Water Resources Department

January 24th, 2017

Re: Wallowa Dam (W-2) - Inspection Summary

Gate tunnels 5 (open) and 4 (closed)

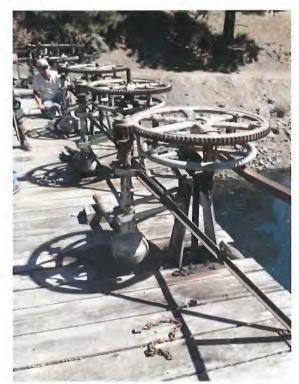
There are five gates that control the flow to each of the five outlet tunnels. The gates are manually operated frequently. The conduit tunnels experience continued deterioration, delamination and spalling, and calcium carbonate efflorescence (spires) from seepage. As was the case in past inspections, the gates cannot be completely closed and leak significantly. During the inspection, the operator closed the gate valves as much as possible so that we could observe the amount of leakage from the gates. The gates are numbered consecutively starting from the left abutment. Gates 1, 3, and 5 leak when closed, while Gates 2 and 4 do not. The leakage, in cubic feet per second (cfs), through gates 1, 3, and 5 was estimated at 20 cfs, 14 cfs, and 6 cfs, respectively. At some point in the near future the leakage will prevent effective storage of water.

- 1. The dam needs to be rehabilitated or replaced very soon. The process for rehabilitation/replacement can be lengthy so the process should begin as soon as possible.
- 2. Re-attach the steel liners in the outlet tunnels.
- 3. The gates for the outlet tunnels will most likely not last that much longer. If these fail, you will lose the ability to store water. As a result, these will need to be replaced in the near future.
- 4. Until rehabilitation/replacement, continue to operate this dam as per the restriction we have previously established and continue to enforce.
